# ADDENDUM #1

**PROJECT #:** 242762  
**PROJECT TITLE:** AJ Jolly Dam Repair  
**CLIENT:** Campbell County Fiscal Court  
**Issue Date:** April 21, 2026

SHEET  
G-103

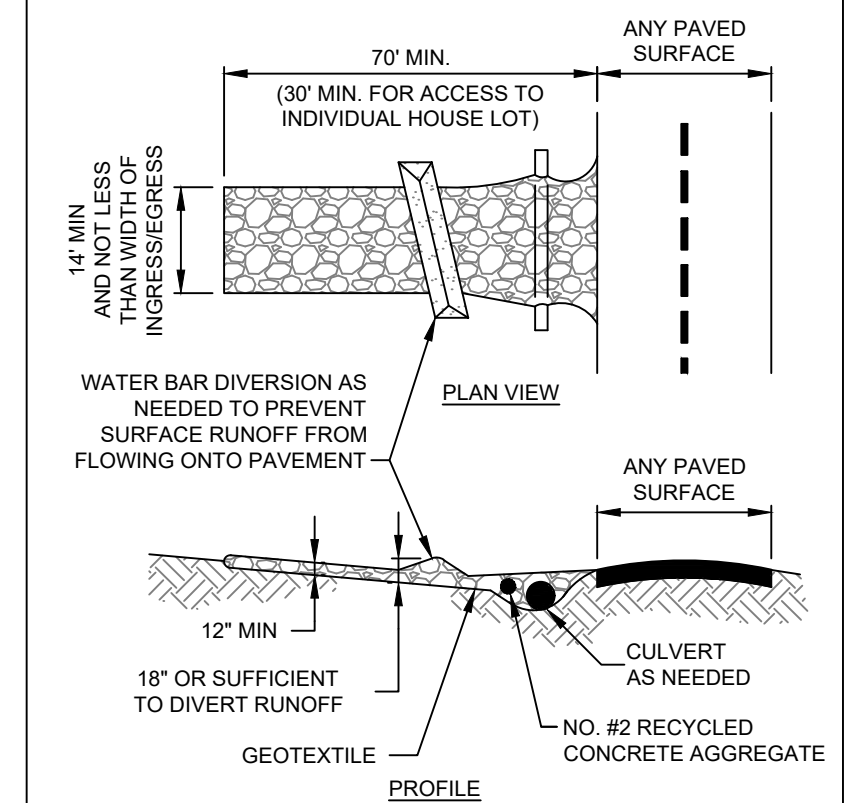
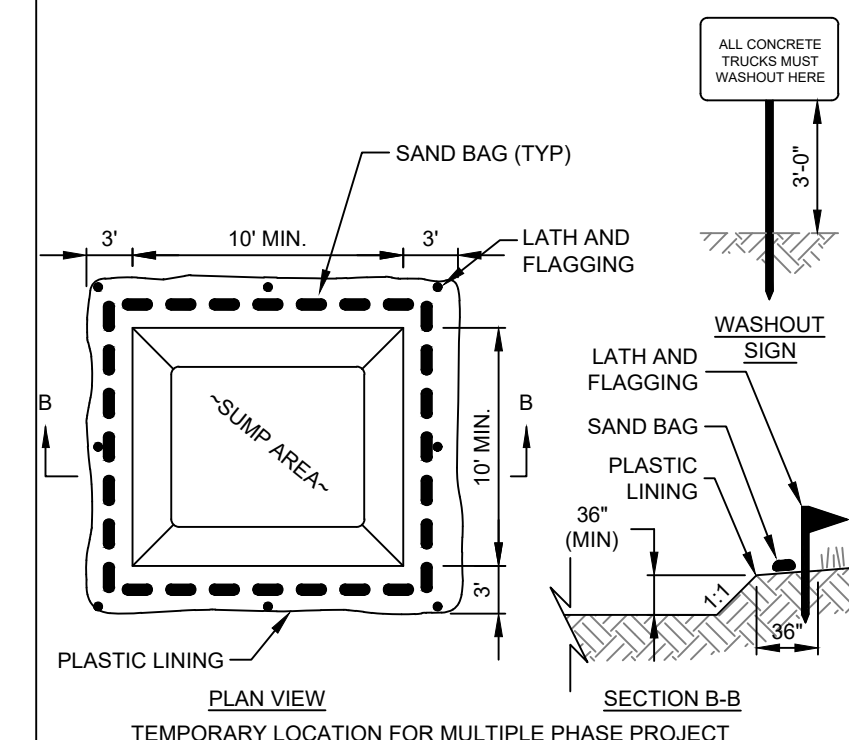
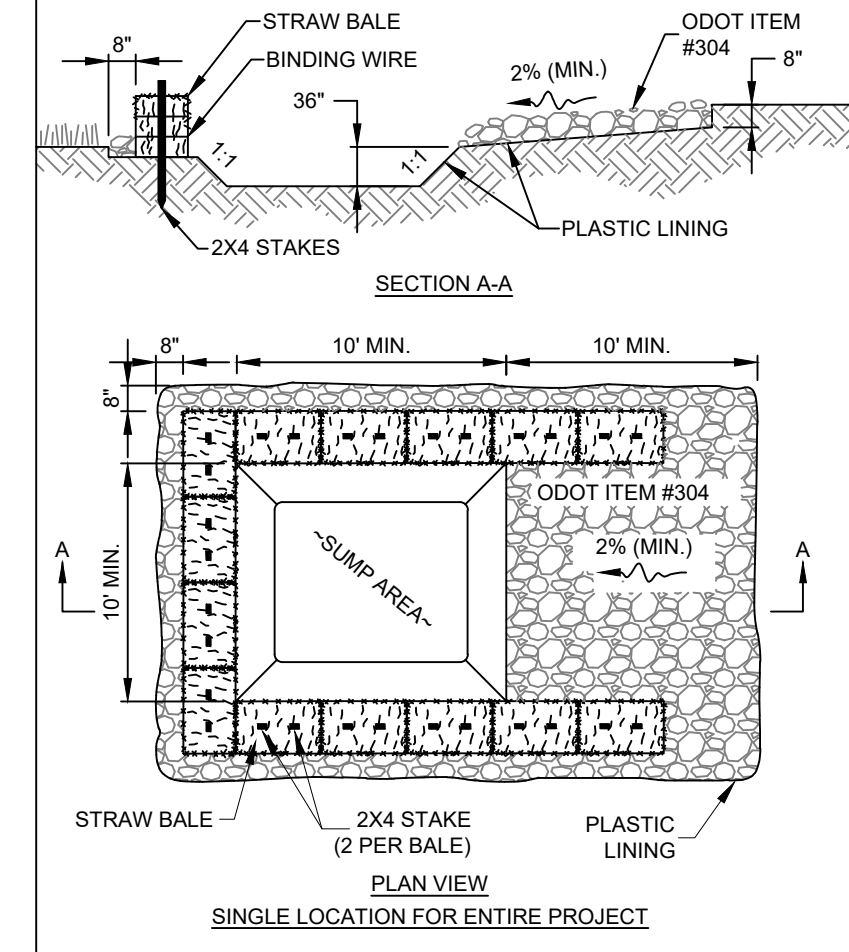
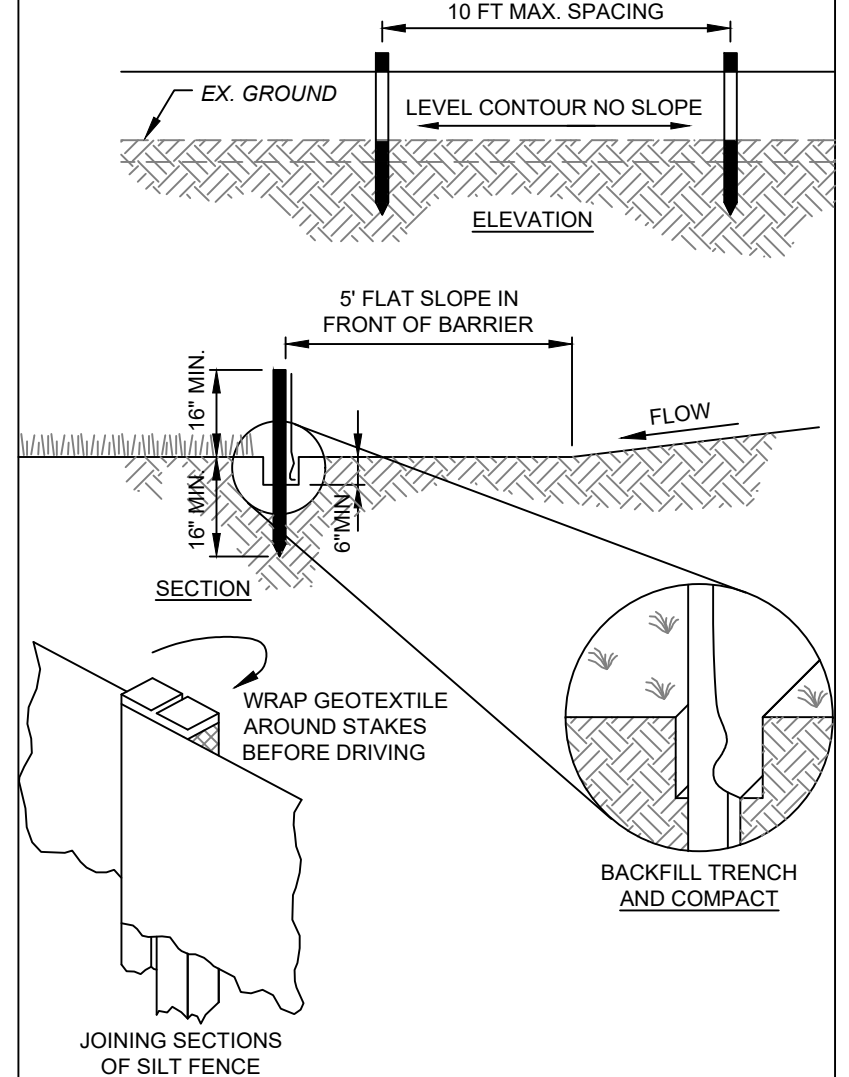
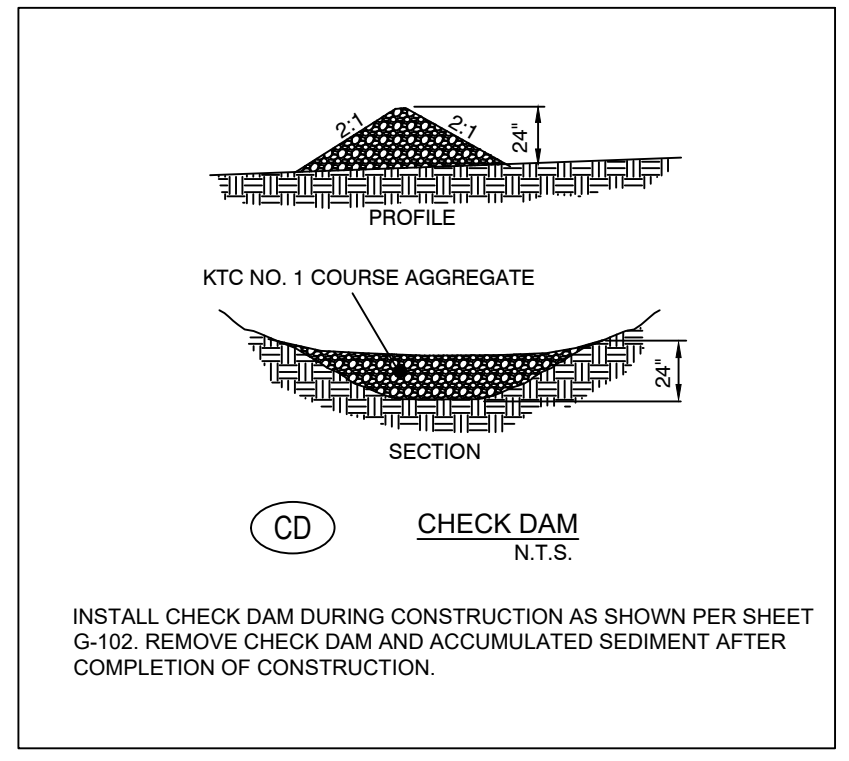
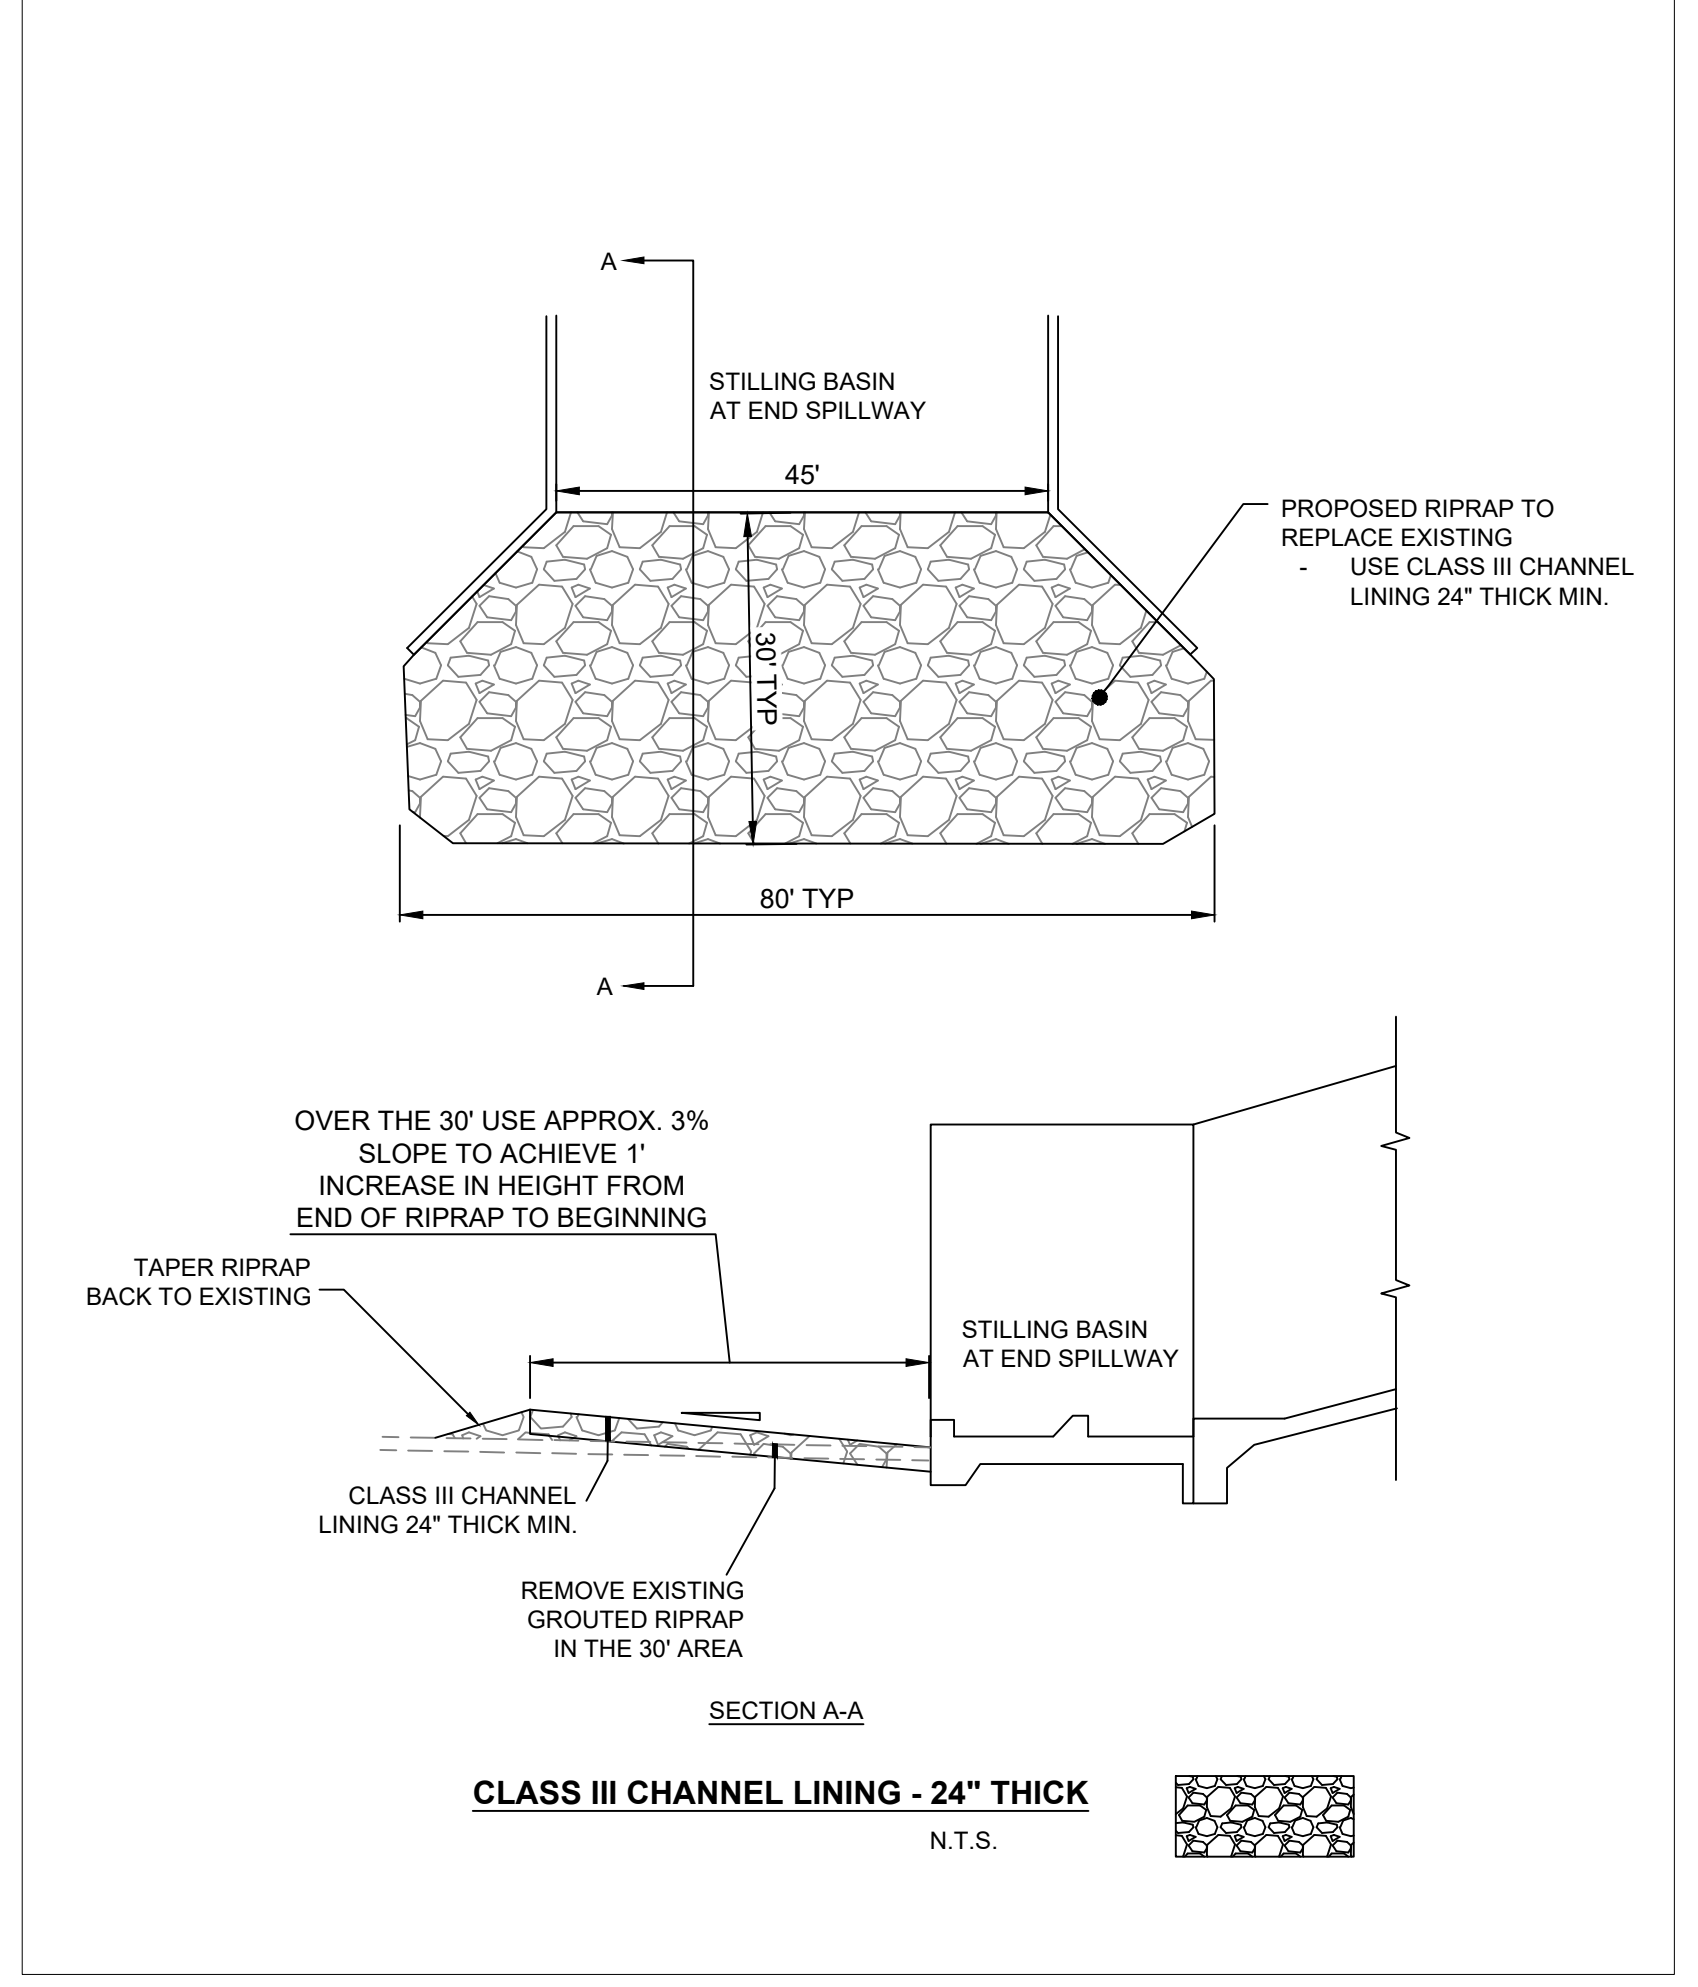
SHEET G-103  
*Renamed Grouted Riprap Detail to Class III Channel Lining Detail and removed all mentioned of Grouted Riprap.*

SHEET: G-104

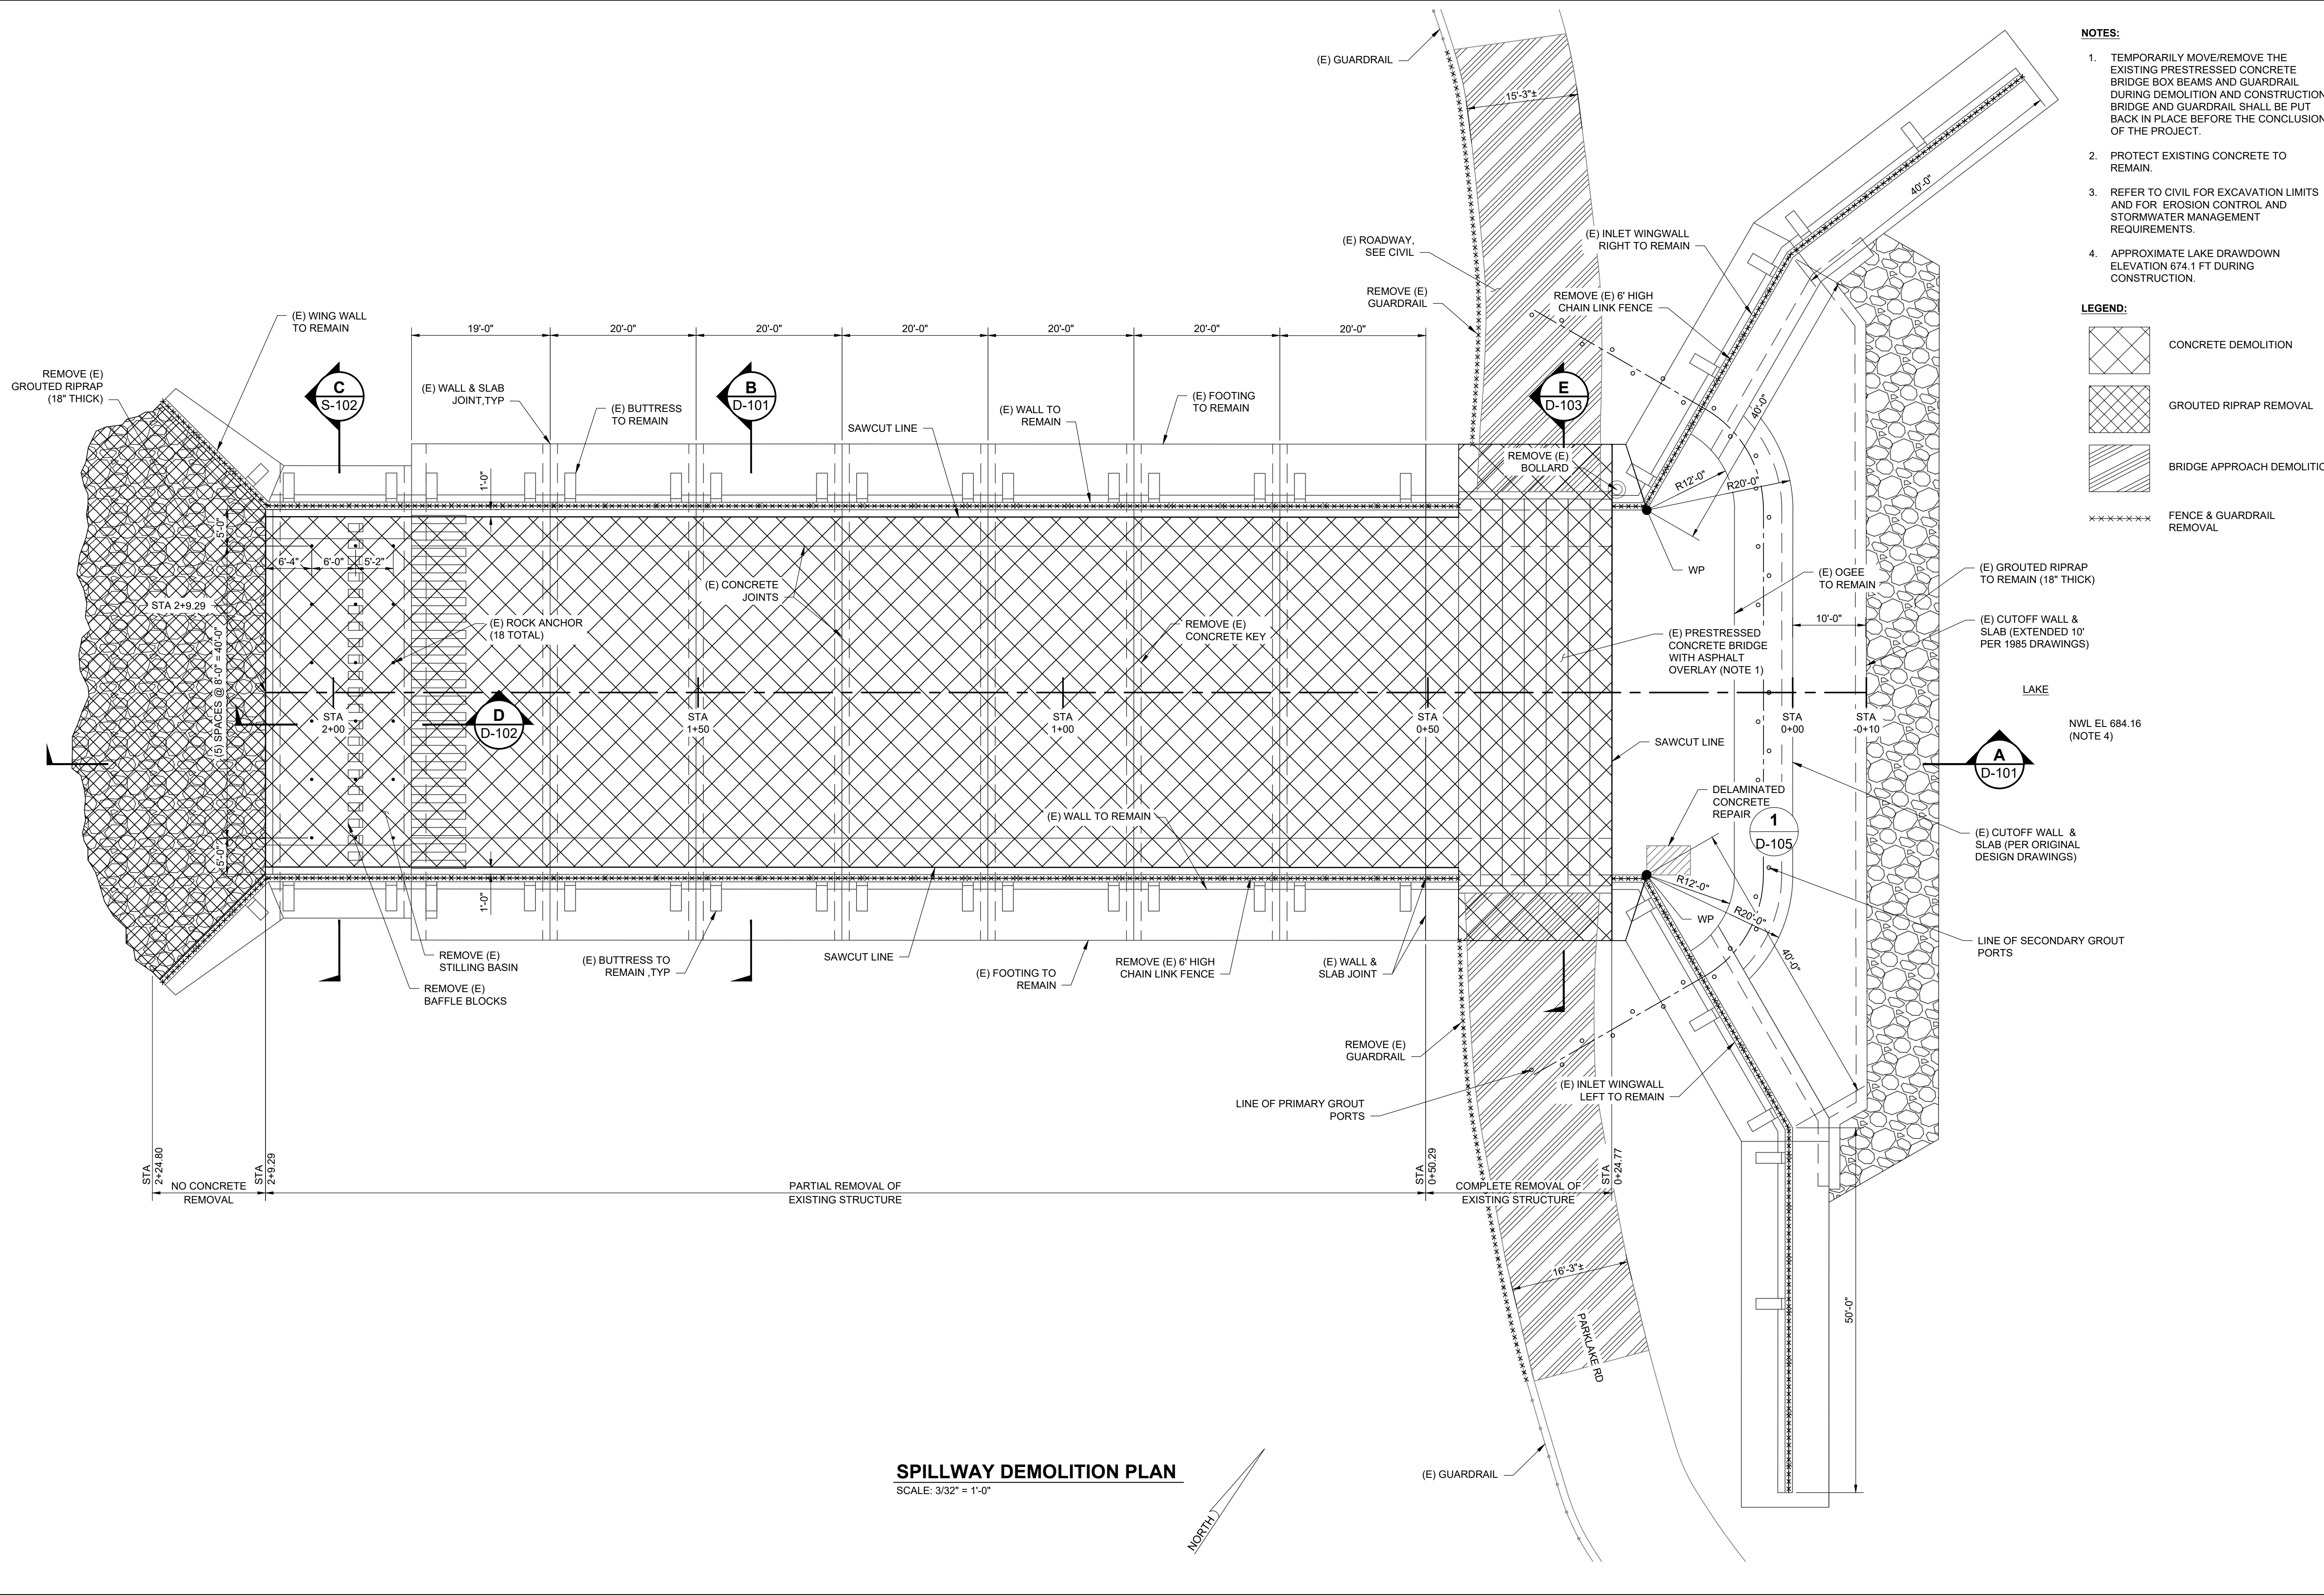
Bid Form Item 9: Sawcut and remove existing asphalt pavement. Please show the limits of this work on a drawing.

Bid Form Items 15, 16 and 17: Asphalt reconstruction of roadway. Please show the limits of this work on a drawing.

SHEET G-104  
*Renamed Asphalt Roadway Reconstruction Section to Asphalt Reconstruction of Roadway. This matches Bid Form Items 15, 16, and 17.  
Also revised keynote 3 language for this detail, and removed mentioned of geotextile.*

*Response: Bid Item 9 has been updated. The limits of this work is shown on page G104 with the Asphalt Reconstruction of Roadway Section Hatch and on page D100 with the Bridge Approach Demolition Hatch. This quantity has also been revised.*

*Response: The limits of work on Bid Items 15, 16 & 17 are shown on page G104 with the Asphalt Reconstruction of Roadway Section Hatch. Quantities for Bid Items 15, 16 & 17 have been revised.*
